SUBSURFACE WASTEWATER DISPOSAL SYSTEM APPLICATION

CROSS HILL RD. PLATT, NANCY
SITE PLAN

8983907: Request for a Holding Tank installation. Platt property. Dam
Pond ~~at~~ Hill Road, Augusta

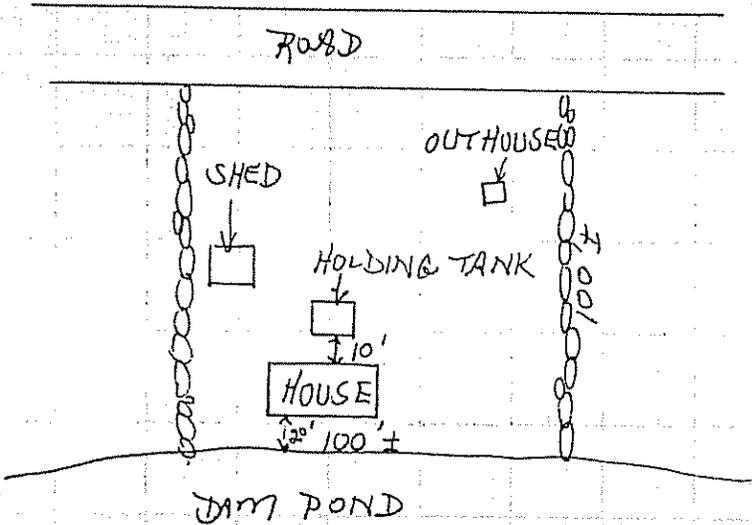
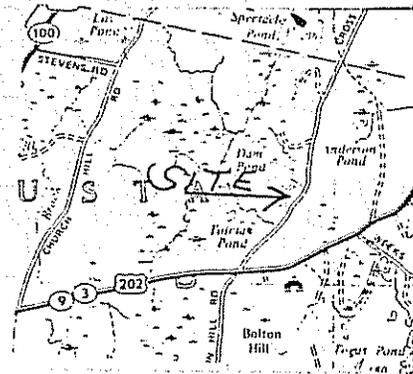
SEE "NOTES FROM THE SITE EVALUATOR" AND COVER LETTER

After reviewing the information, the Division approves the proposed holding tank installation with the following conditions:

1. The installation of a 1500 gallon holding tank with suitable float alarm meeting the construction standards of CMR 241, Section 17.F.1.
2. The Holding Tank is to be used only by a 1 bedroom residence.
